BILTMORE II CONDOMINIUM BUILDING

FORTY-YEAR INSPECTION

**Biltmore II Condominium Building
600 Biltmore Way
Coral Gables, FL 33134**

Project No. 06-269-L

PHOTO # 1: Vertical cracking on building wall located at balcony Unit #219

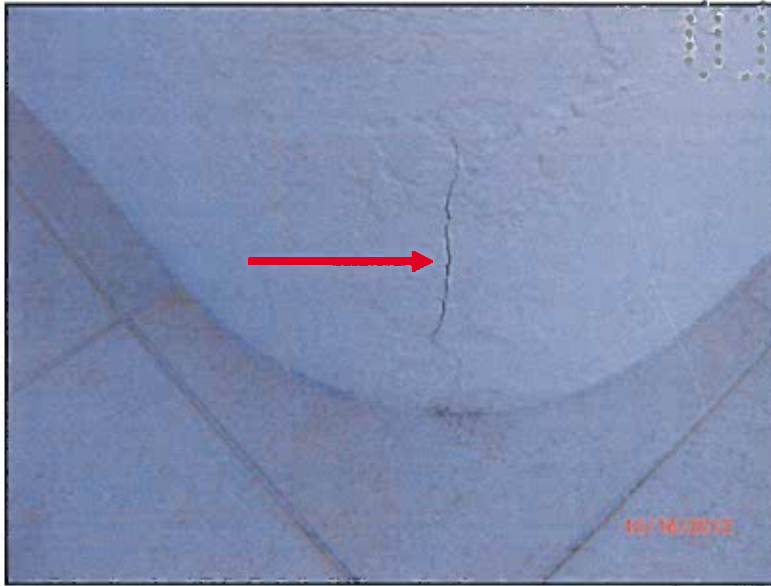
1. The building structure is generally in good condition.
2. The interior walls of balconies are in good condition overall. Minor cracking was observed on interior balcony wall and building wall (photo #1, photo #2 and photo #3) location.

3. The balcony slabs are in fair condition. Spalled concrete with corroded reinforcing steel was noted on the balcony ceilings of Units 219 and 416 (photo #4 and photo #5).

PHOTO # 2: Horizontal cracking/delaminated stucco at balcony wall Unit #219

PHOTO # 3: Horizontal cracking on balcony block wall concrete cap at Unit #219

PHOTO # 4: Concrete spalling/exposed steel rebar at balcony ceiling at Unit #219

Although the edges of the balcony slabs are typically in fair condition, some units exhibit cracking and concrete spalling at the slab edge and at the underside of slab above. This is an indication of moisture intrusion into the concrete, with subsequent corrosion of the reinforcing steel. If left unabated, the concrete at the edges of balconies will eventually spall off, creating a falling debris and life safety hazard for residents and pedestrians below. It's recommended that balcony edges be repaired where there are signs of cracking and concrete spalling. In addition, we also recommend that all balconies be surveyed to document similar conditions.

The walls of the balcony slabs are typically in good condition, the inspected residential units' exhibit cracking at balconies. This is an indication of moisture intrusion into the block wall, with subsequent delamination of stucco. If left unabated, the stucco at the balcony block wall will eventually spall off, creating a falling debris and life safety hazard for residents and pedestrians below. We recommend the balcony walls be repaired where there are sign of cracking and

PHOTO # 5: Concrete spalling at balcony ceiling at Unit #416

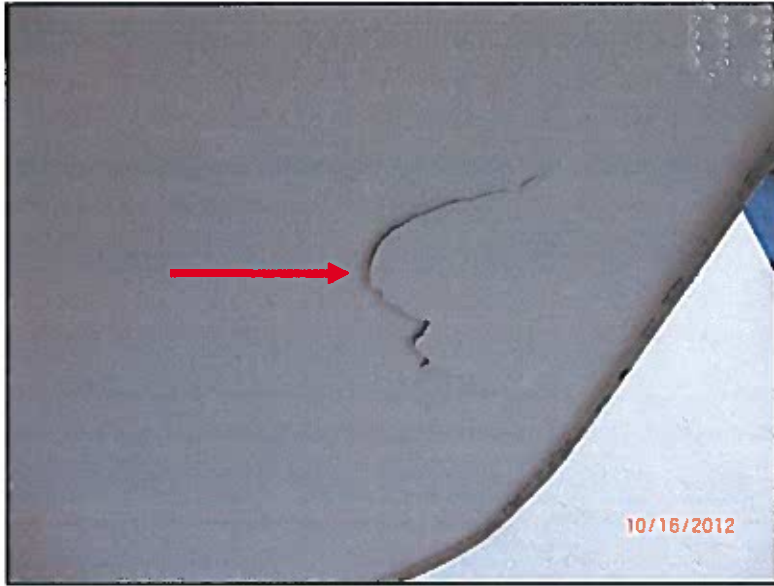
4. Minor stucco cracking at balcony railing connection to block wall of Unit 407 (photo #6).
5. We observed stucco cracking along balcony's edge of Unit 407 (photo #7) and connection between block wall and building column of Unit 219 (photo #8).

PHOTO # 6: Cracking stucco at balcony railing connection at Unit #407

PHOTO # 7: Cracking/delaminated stucco on balcony slab edge at Unit #407

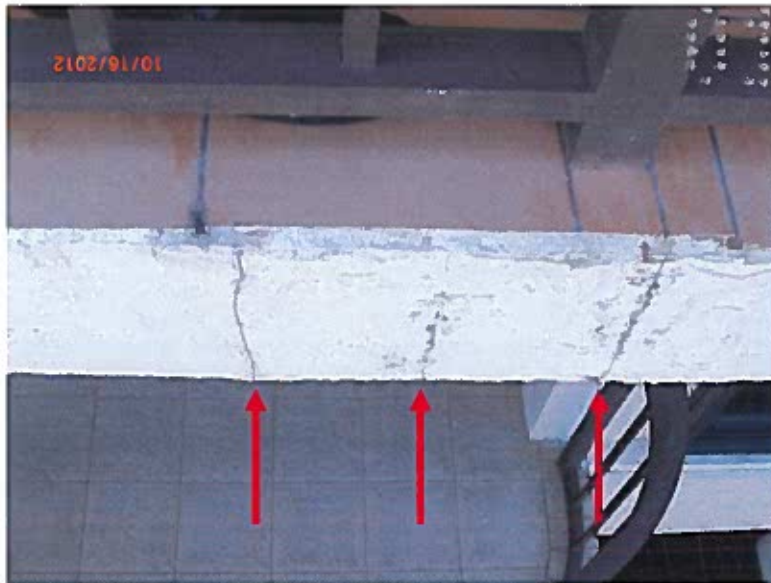
6. The roof edges of the Generator Room (photo #9) and East Elevator Machine Room (photo #10) at Roof Area have fine horizontal cracks which exhibit signs of water infiltration.

7. The interior block wall at the east side of the Elevator Machine Room at the Roof Area was observed with step cracking (photo #11).
8. The roof edge of the Penthouse exterior wall (photo #12) was noted with fine horizontal cracks which exhibit signs of water infiltration.

PHOTO # 8: Cracking at connection between balcony wall and bldg. column at Unit #219

PHOTO # 9: Delaminated/cracking stucco at exterior of Generator Room at roof area

PHOTO # 10: Delaminated/cracking stucco at exterior of east Elevator Machine Room at Roof Area

PHOTO # 11: Step cracking at corners of east side Elevator Machine Room

PHOTO # 12: Horizontal cracking at PH exterior wall

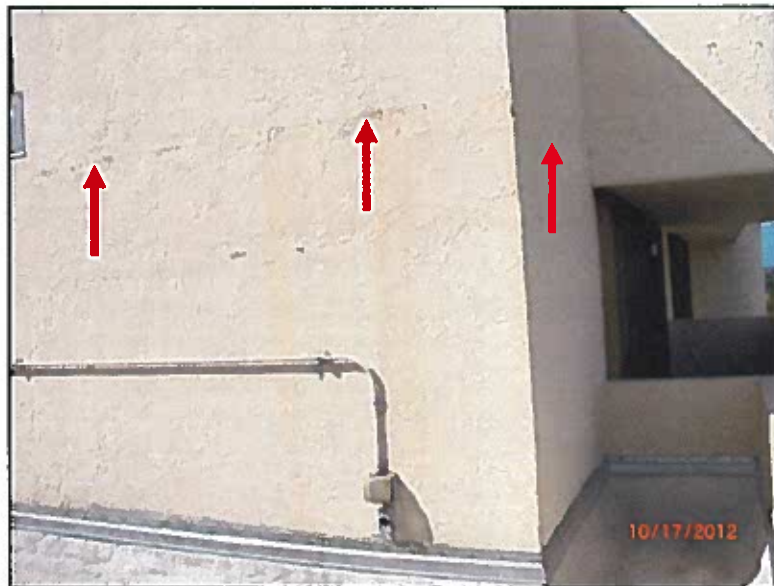
9. The interior block wall at the West Elevator Machine Room is not mortared properly at patched area (photo #13).
10. Hair Line cracking across column drop panel next to Parking Space No. 267 (photo #14 and photo #15).

PHOTO # 13: Cracks on block wall at inside of West Elevator Machine Room

PHOTO # 14: slab cracking at column drop panel next to Parking Space No. 267

PHOTO # 15: slab cracking at column drop panel next to Parking Space No. 267

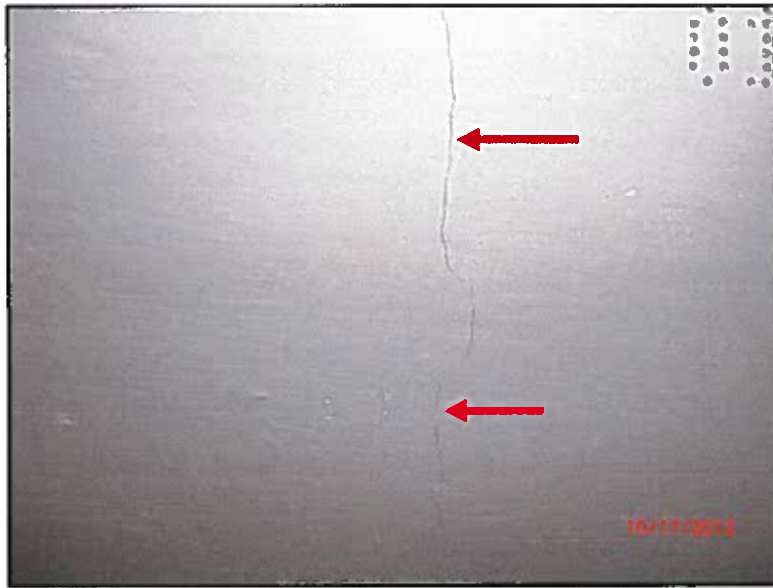
11. Unsealed wall pipe penetration at fire rated separation (2hr Fire rate assembly) (photo #16).
12. Hair line cracking on slab and beam was noted next to Parking Space No. 210 (photo #17 and photo #18).

**PHOTO # 16: Unsealed wall, pipe penetration at Fire rated assembly (2hr fire rated assembly)
Paint Storage Room**

PHOTO # 17: slab cracking and beam cracks next to Parking Space 210

PHOTO # 18: slab cracking at column drop panel next to Parking Space 210

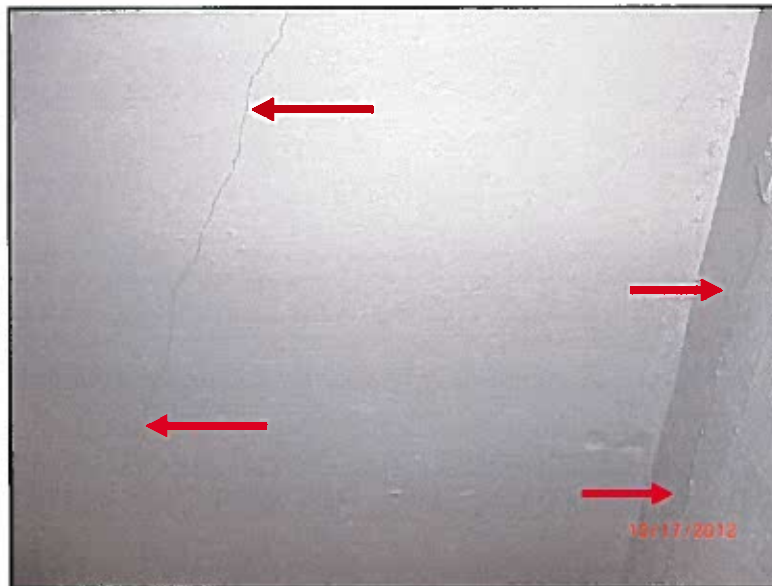
13. Hair line cracking across column drop panel between Parking Space No. 248 & 249 (photo #19).
14. Hair Line cracking at column drop panel corner between Parking Space No. 245 & 246 (photo #20).

PHOTO # 19: slab cracking at column drop panel between Parking Spaces 248 & 249

PHOTO # 20: slab cracking at column drop panel between Parking Spaces 245 & 246

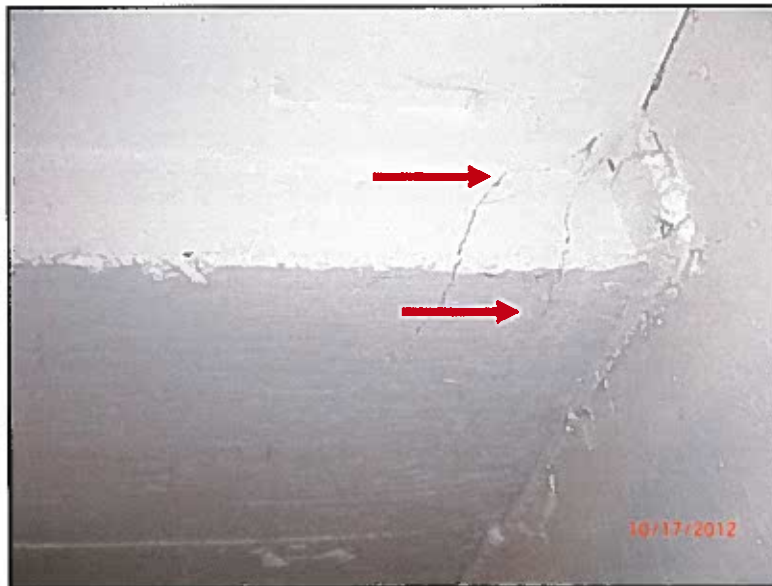
15. Trench drain drop ceiling opening over flows at opening between Parking Spaces No. 314 & 327 (photo #21 and photo #22).
16. Surface cracking and water intrusion was noted at underside of ramp on front of Parking Space No. 61 (photo #23).

PHOTO # 21: trench drain drop ceiling between Parking Spaces 314 & 327

PHOTO # 22: trench drain drop ceiling opening between Parking Spaces 314 & 327

PHOTO # 23: cracking and water intrusion at underside of ramp in front of Parking Space 61

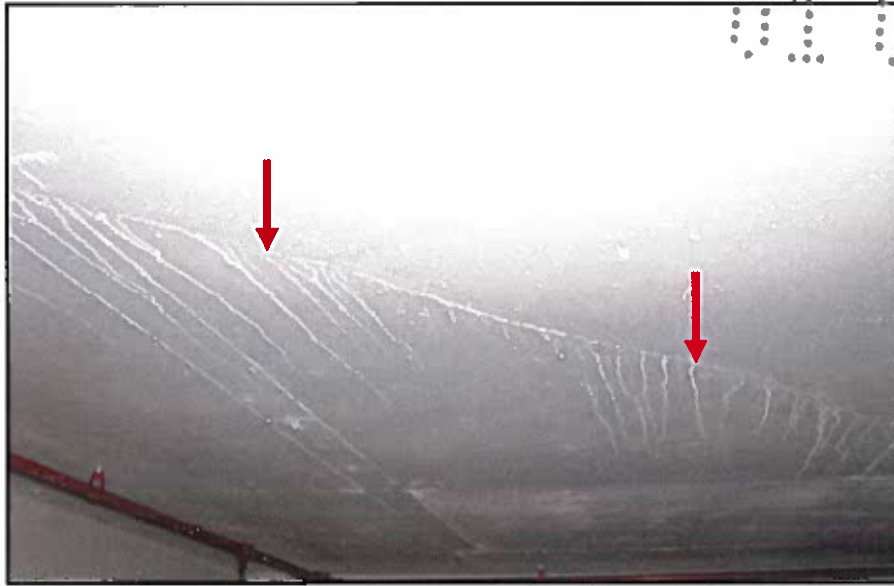
17. Trench drain drop ceiling opening over flows at opening between Parking Space No. 52 & 61 (photo #24 and photo #25).
18. The East end of the Parking Garage wall exhibits hair line cracking next to Parking Space No. 51 (photo #26).

PHOTO # 24: trench drain drop ceiling between Parking Spaces 52 & 61

PHOTO # 25: trench drain drop ceiling between Parking Spaces 52 & 61

PHOTO # 26: cracking on wall next to Parking Space 51

PHOTO # 27: Unsealed wall, pipe penetration at Fire rated assembly (2hr fire rated assembly)
Paint Storage Room

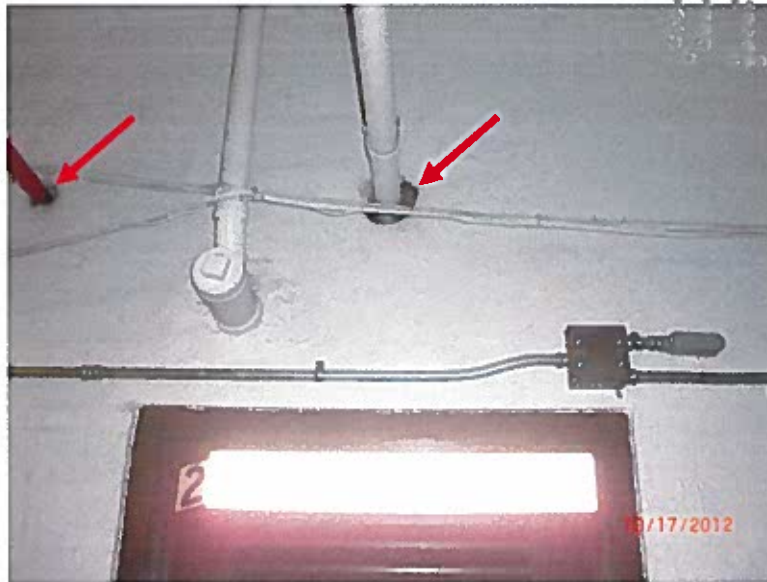
19. Unsealed wall pipe penetration at fire rated separation (2hr Fire rate assembly) above Fire Pump Room door (photo #27).
20. Hair Line Cracking on Overhang at West side (photo #28).

PHOTO # 28: cracking on overhang at West side

PHOTO # 29: cracking and staining on balcony edge

PHOTO # 30: cracking & blistering at underside of overhang edge

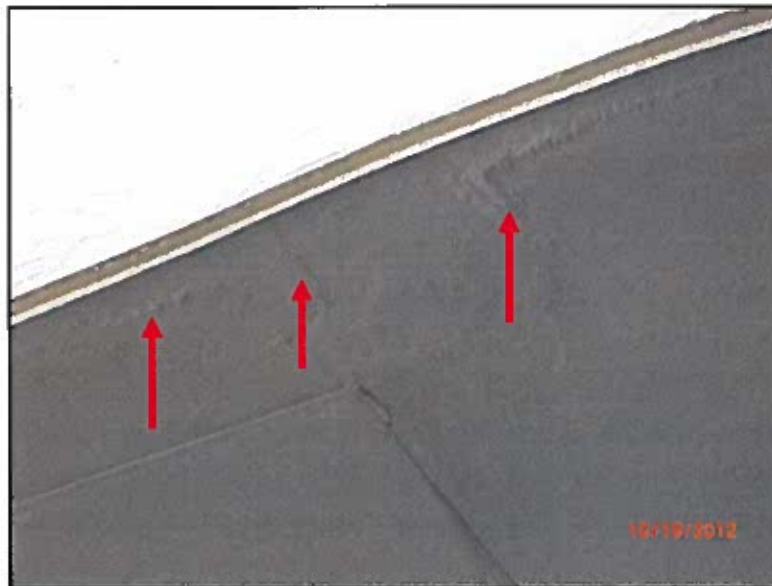
21. Hair Line Cracking and staining on balcony edge at Third level on north side (photo #29).
22. Blistering and underside cracking was observed at Overhang (photo #30).

PHOTO # 31: stucco cracking at bottom of third floor balcony wall on East side

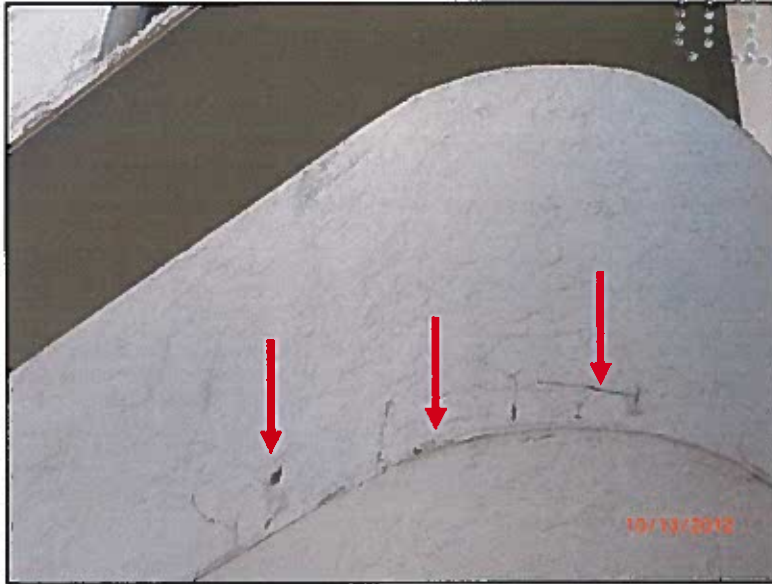
23. Cracking at bottom of balcony wall was noted (photo #31).
24. Crack along tiled pedestrian ramp east of main entrance was observed (photo #32).
25. Delaminated stucco and cracking at bottom of fourth floor balcony wall on east (photo #33).

PHOTO # 32: crack along tiled ramp east of main entrance

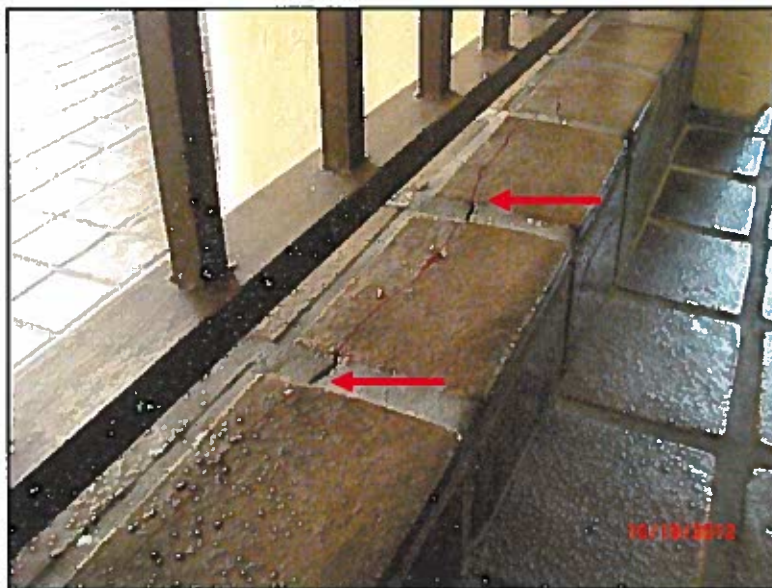
26. Surface cracks on building shear wall next to window shutter next to east stairs tower (photo #34).
27. Spider web cracking on exterior face at first balcony on East side (photo #35).

PHOTO # 33: cracking and staining at bottom of fourth floor balcony wall on east

PHOTO # 34: stucco cracking on building wall next to east stairs tower

PHOTO # 36: ceiling separation at edge of South overhang

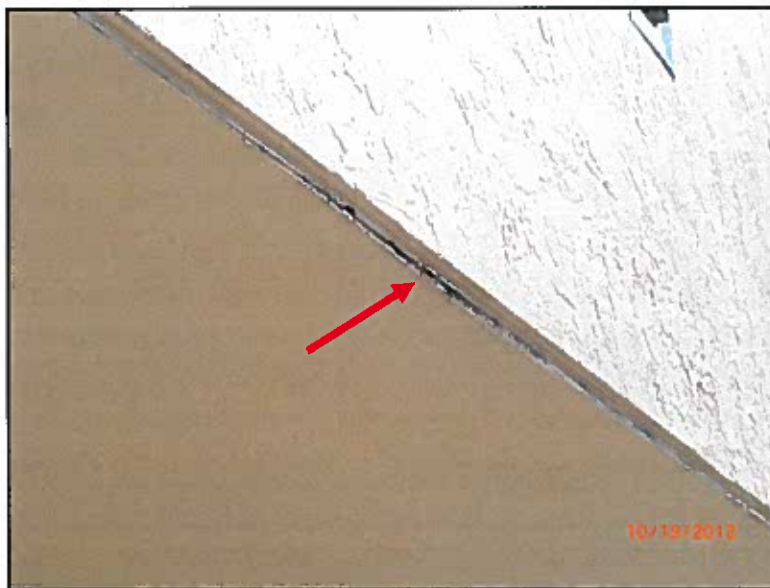
28. Ceiling panel separation at edge of South overhang (photo #36).
29. Stucco cracking on East side of building corner at Pool Deck Area (photo #37).
